Access Compliance Report

Public Rights-of-Way

(Curb Ramps)

Intersection ID: 27450	Main Street: PROVINCETOWNE_DR	Cross Street: WILLIAMS_POND_LN	Location: SW
ADA ID: CBBF3B828BBE	Ramp Type: PerpDiag	Initial Pass/Fail: Fail	Overall Compliance: No
Severity Score: 21.25			
Codes/Mitigation Info/Possible Solution		Field Measurements/Component Compliance

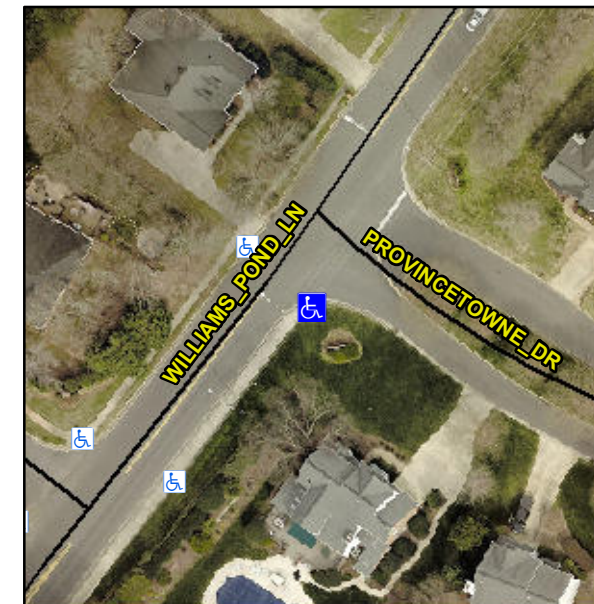
Not Found, R304.5.1, R304.5.3

Compliance	Description	Data	Compliance	Description	Data
N/A	Ramp Length (in)	70.0	Yes	Ramp Slope (%)	7.0
No	Ramp Width (in)	44.0	No	Ramp XSlope (%)	5.9
N/A	Flare Type LT	N/A	N/A	Flare Type RT	N/A
N/A	Flare Slope LT (%)	N/A	N/A	Flare Slope RT (%)	N/A
N/A	Flare Traversable LT?	N/A	N/A	Flare Traversable RT?	N/A
N/A	Landing Length (in)	N/A	N/A	DWS Provided?	N/A
N/A	Landing Width (in)	N/A	N/A	DWS Contrast?	N/A
N/A	Landing Slope (%)	N/A	N/A	DWS Length (in)	N/A
N/A	Landing X Slope (%)	N/A	N/A	DWS Full Width?	N/A
N/A	Landing Curb? (Y/N)	N/A	N/A	DWS Offset (in)	N/A
N/A	Shared Landing?	N/A			
N/A	Gutter Ponding?	N/A	N/A	Gutter Slope (%)	N/A
N/A	Gutter Lip Ht (in)	N/A	N/A	Gutter X Slope (%)	N/A
N/A	Painted X Walk1?	No	N/A	Painted X Walk2?	No
	X Walk 1 Direction	To NE		X Walk 2 Direction	To NW
N/A	X Walk 1 Width (in)	N/A	N/A	X Walk 2 Width (in)	N/A
	X Walk 1 Slope (%)	0.9		X Walk 2 Slope (%)	6.5
	X Walk 1 X Slope (%)	5.2		X Walk 2 X Slope (%)	1.3

N/A	Ramp inside XWalk1?	N/A	N/A	Ramp inside XWalk2?	N/A
	Road Slope (%)	4.6	N/A	Clear Space?	N/A
	Road X Slope (%)	3.2	N/A	Clear Space to XWalk (in)	N/A
N/A	Any Obstructions?	N/A	N/A	Storm Grate/Utility Hazard?	N/A
	Obstruction Type			Storm Grate/Utility Type	
		N/A			N/A
			Yes	Surface Condition? (G/P)	Good

Remove & Replace Curb Ramp With Two New Directional Ramps or Equivalent.
